REG.REF. 91A/115

RE: Development at Kilakee, Rathfarnham

RE: Application for house at Kilakee, Rathfarnham, Dublin 16.
Reg. Ref. 91A/0115.

Register Reference : 91A/0115

TYPICAL PLAN & SECTION OF SEPTIC TANK, DISTRIBUTION BOX & PERCOLATION AREAS

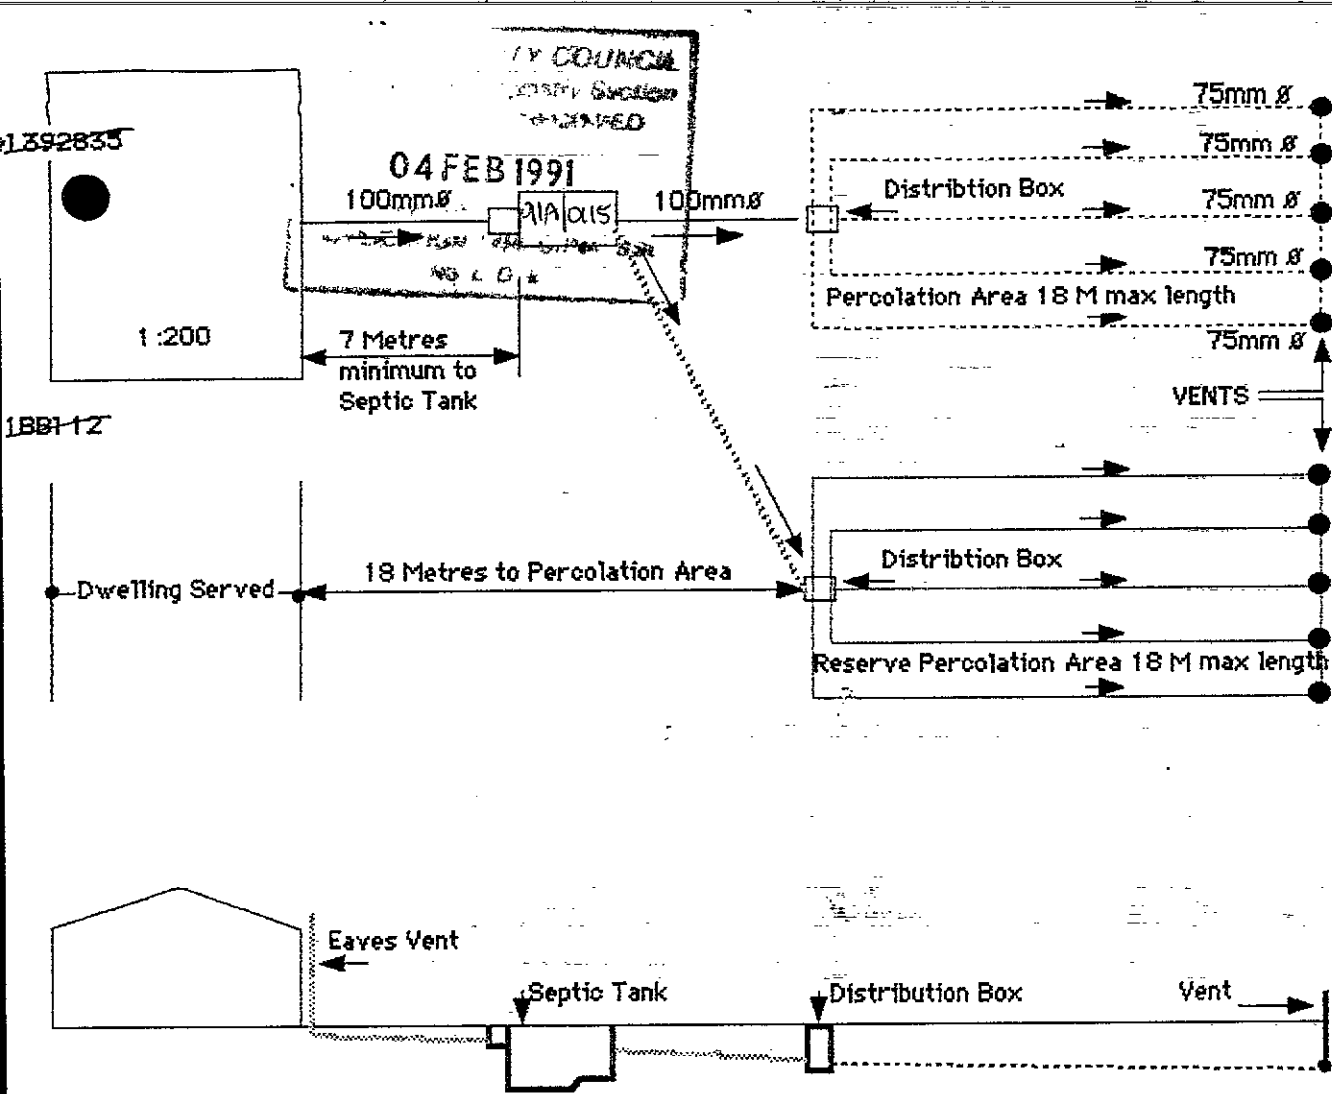
1. The exact location of the proposed well must be indicated on the plan with no part of the percolation area within 150m
2. No evidence of a potable and adequate water supply given
3. The proposed drainage is not in accordance with S.R. 6 i.e. there are no distribution boxes indicated in the plan of percolation and reserve percolation areas, no details of septic tank design and specifications.

Date	Scale
	1:1000
Dwg No	Title
11901BBL 2	Site Plan B

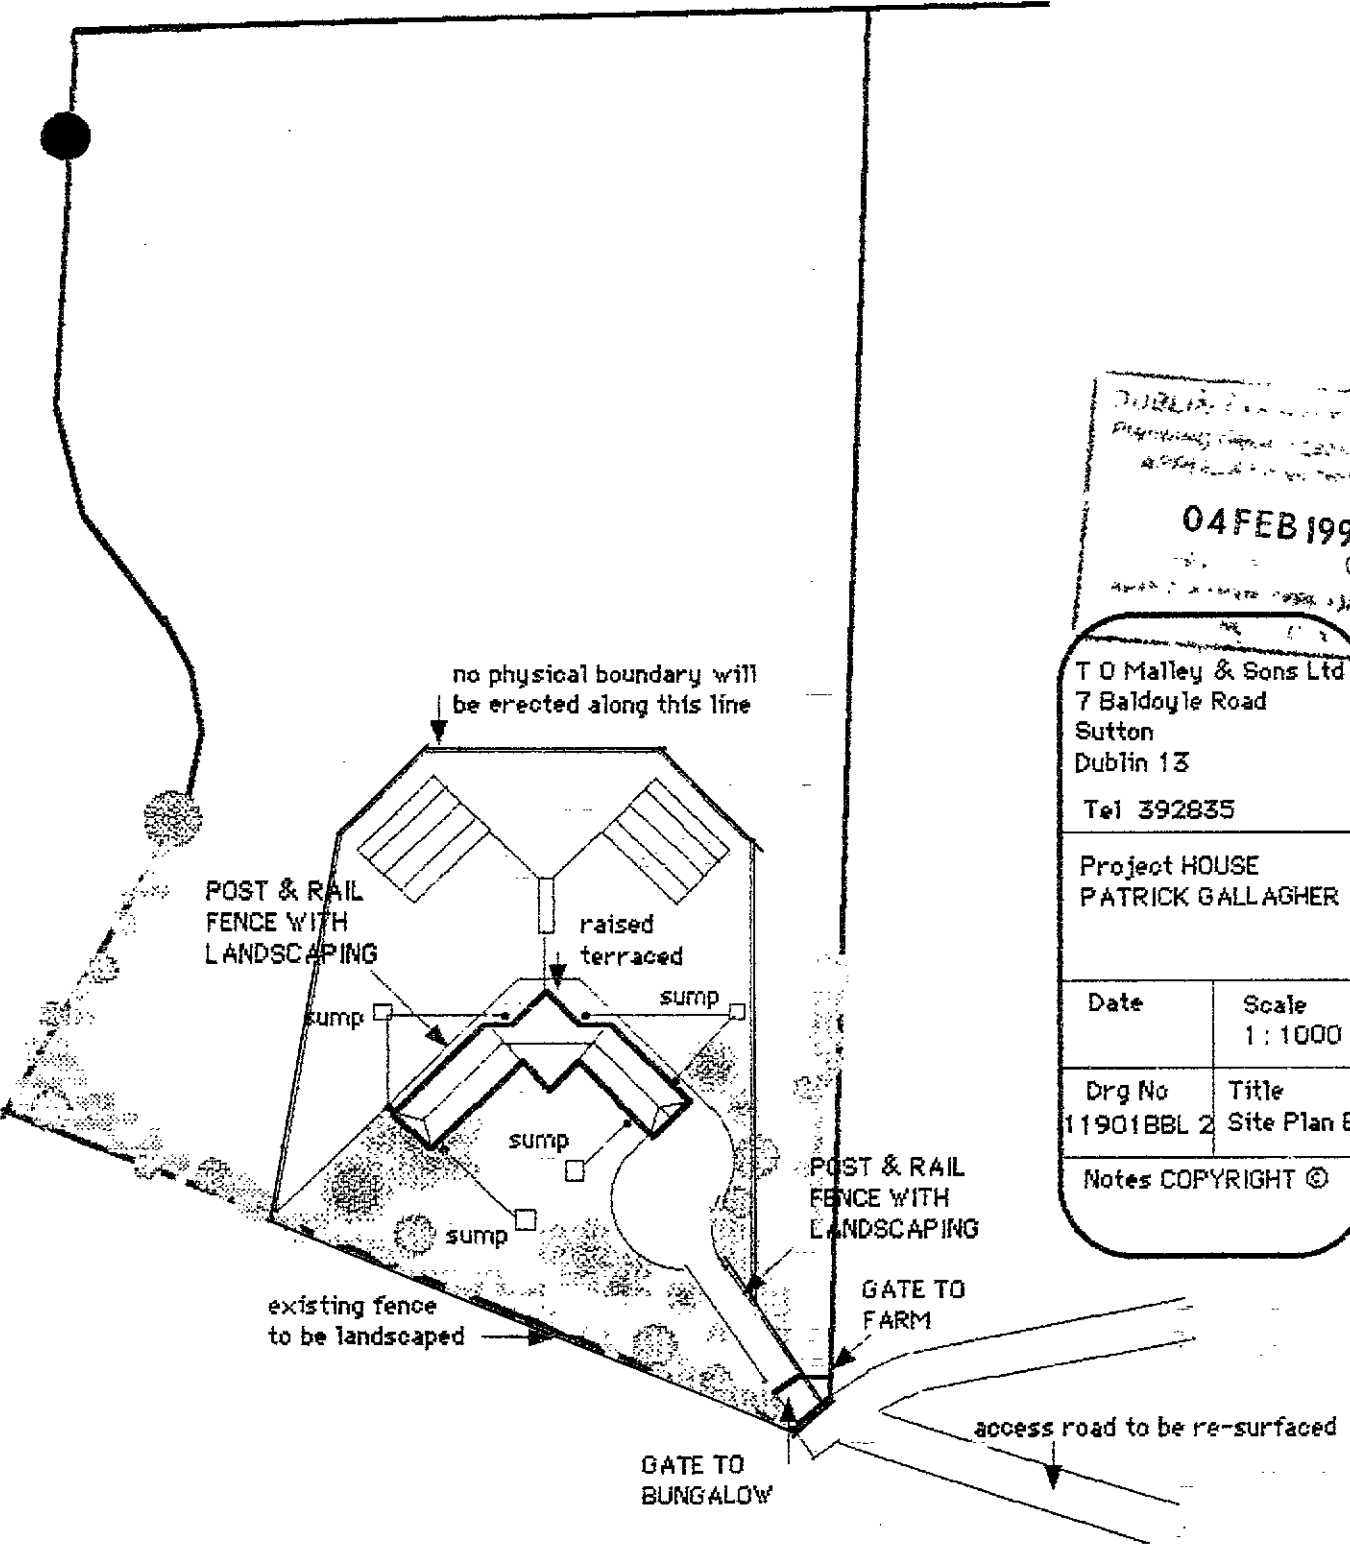
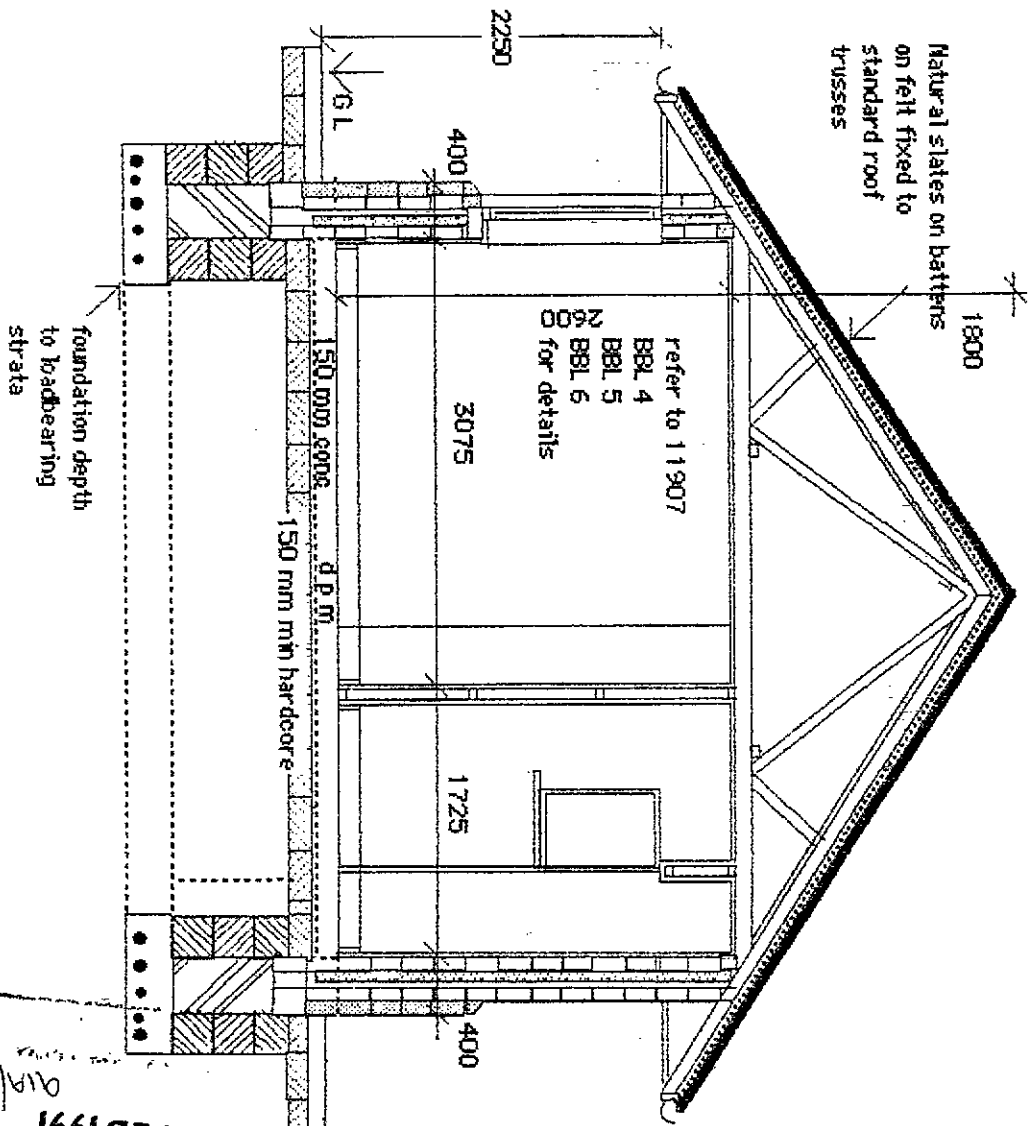
The map attached to the file does not extend sufficiently to indicate the location of the entrance to the site. The lands to the north of Cruagh Road form a virtual precipice, implying any entrance will be difficult and extremely blind. A continuous white line runs along the centre of almost the entire length of Cruagh Road which has a tortourous vertical and horizontal alignment.

The applicant should be requested to submit details of his proposed access to the public road indicating sight lines and vertical alignments at his proposed driveway entrance over the first 50 metres from the public road.

We have revised our site plan to indicate the position of the well in accordance with S R 6 1975. We have also re-positioned 2 rainwater sumps from their original location in the private garden area south of the house to new positions to the North East and North West to avoid any possible contamination of the well. We would also point out that the site falls from South to North in consequence the natural drainage of the site will be away from the well position.
